# Software Update Notification

**Mastersizer 2000 version 4.00  
Application Software for use with (English) Microsoft  
Windows NT and Windows 2000**

**(Part Number PSS0002/6)**

Figure 1: SOP Editor Report/Saving screen

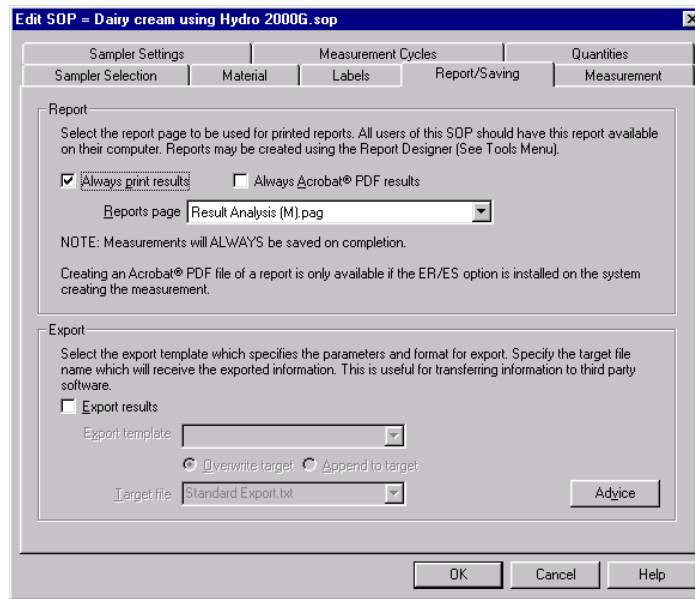
### Printing Results to PDF files for Electronic Signature

If the Electronic Records/Electronic Signatures (ER/ES) feature has been enabled (by purchase of a decryption key) and Acrobat® is installed on a machine, it is possible to create a PDF file automatically at the end of an SOP measurement.

The PDF file will be created with the name of the current measurement file with the record number of the result appended to it. The file will be created in the directory specified in the ER/ES settings.

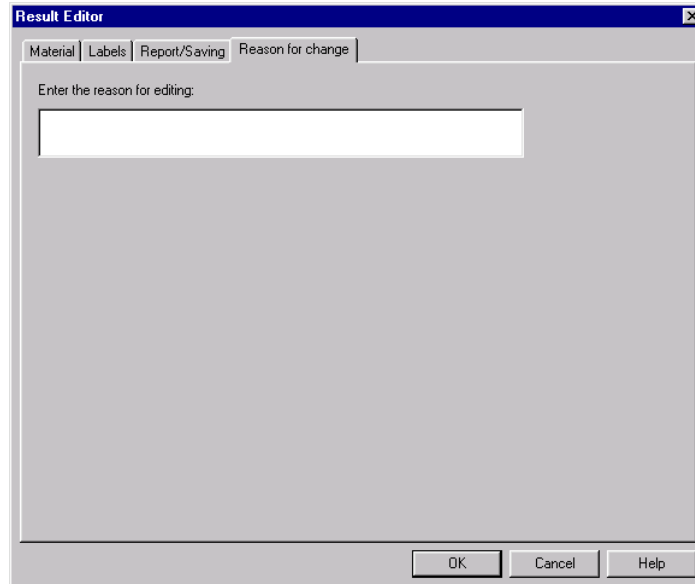
## Editing Results

There is a new tab on the edit results screen that is only visible when ER/ES is enabled. This allows the operator to add a reason for changing the record. This is required by the FDA under 21 CFR Part 11.

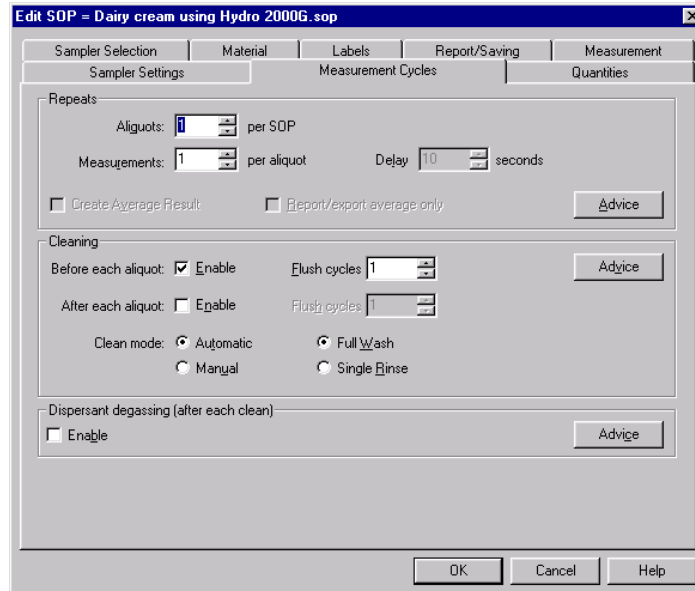
## 8. Abbreviated clean cycle on the Hydro 2000 S/G wet accessories.

The automatic wet accessories (hydro G/S) have a new faster clean cycle option. This is suitable for non-persistent sample materials.

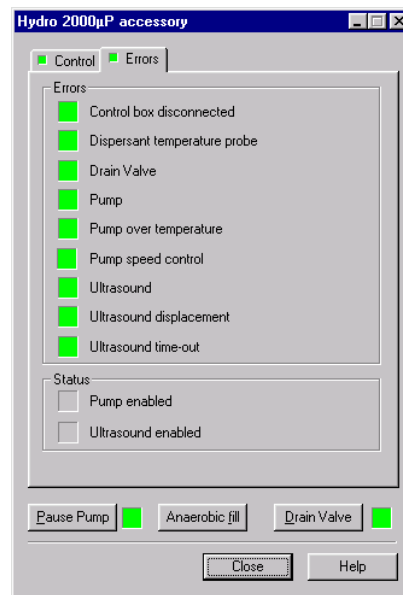
## 9. Improved diagnostics on the Hydro 2000 $\mu$ P.
